# Bridge Design Memorandum

**To:** Bridge Design  
**From:** JMW/sww  
**Date:** 12/1/2014  
**Re:** Detour Bridges – REV. 12-1-14

**DETOUR BRIDGE OVER KAY BAYOU**  
Scale 1" = 10'-0"

**To:** Bridge Design  
**From:** NJA/sww  
**Date:** 2/2/2012  
**Re:** Detour Bridges

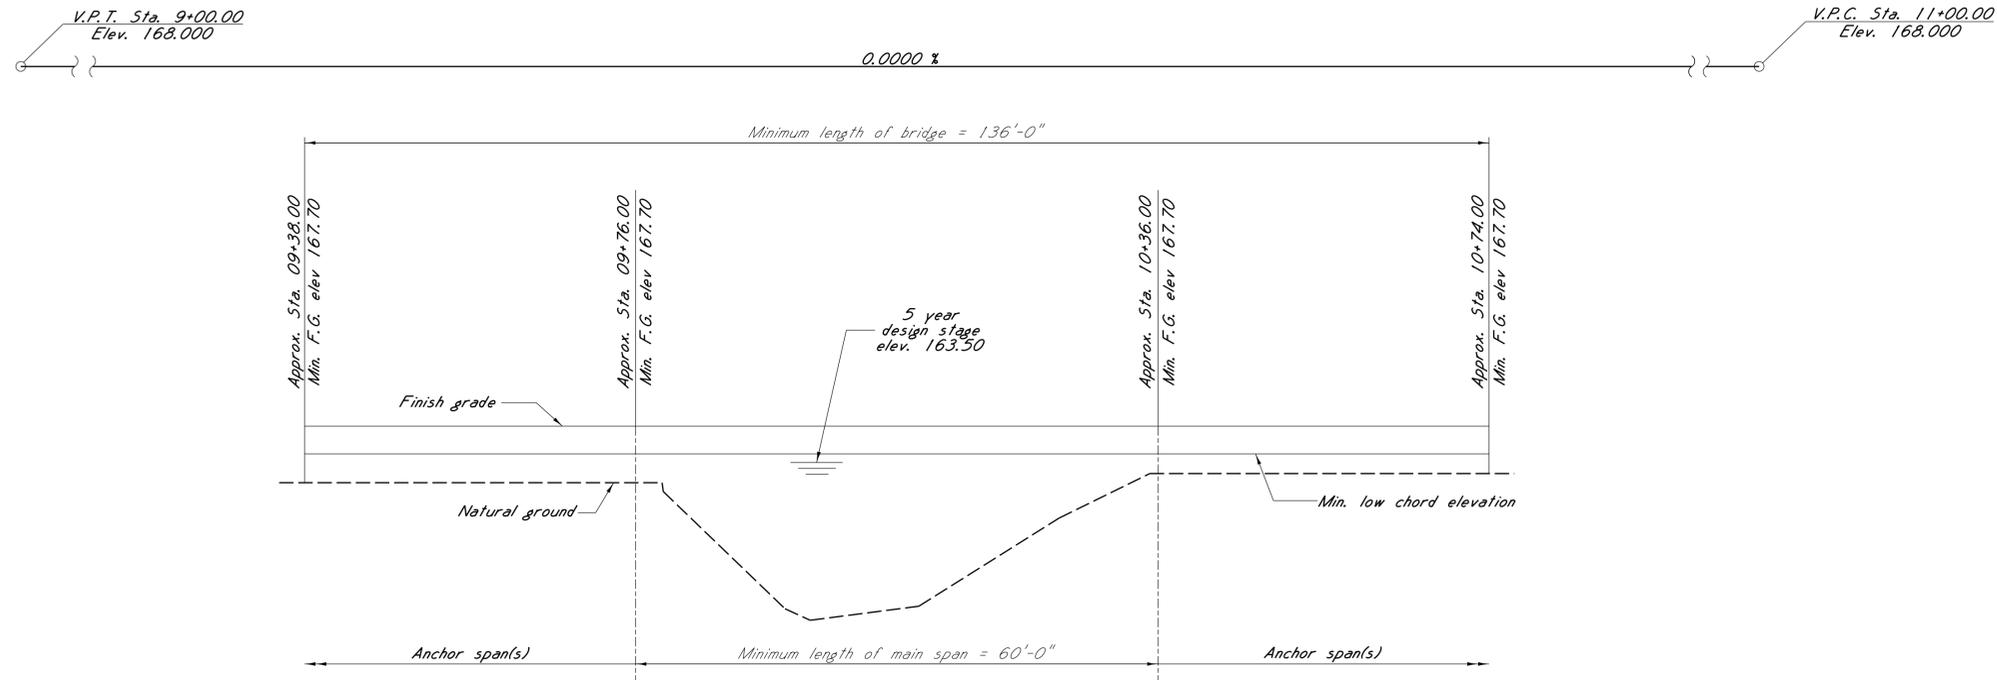
1. All detour bridge submittals shall be reviewed by the hydraulics section before distribution. This is to ensure the detour bridge meets the minimum hydraulic requirements.
2. The Detour Bridge Recommendation Form has been revised by Hydraulics Division. **Please note that data on this form has changed.**
3. The way Detour Bridge is depicted on the Detour Bridge sheet has been revised. General Notes and Drainage Data on the Detour Bridge sheet have been revised as well. Please see the attached sheet as an example.
4. The Drainage Data should read as follows:

Drainage Area..... sq. mi.  
Q5 (U.S.G.S.)..... c.f.s  
Min. Low Chord Elevation.....  
Minimum anchor span length.....19'-0"

**DRAINAGE DATA:**

Drainage area . . . . . 2.49 sq. mi.  
 05 (U.S.G.S.) . . . . . 350 c.f.s.  
 Min. low chord elevation . . . 164.50 ft.  
 Anchor span minimum length . . . 19'-0"
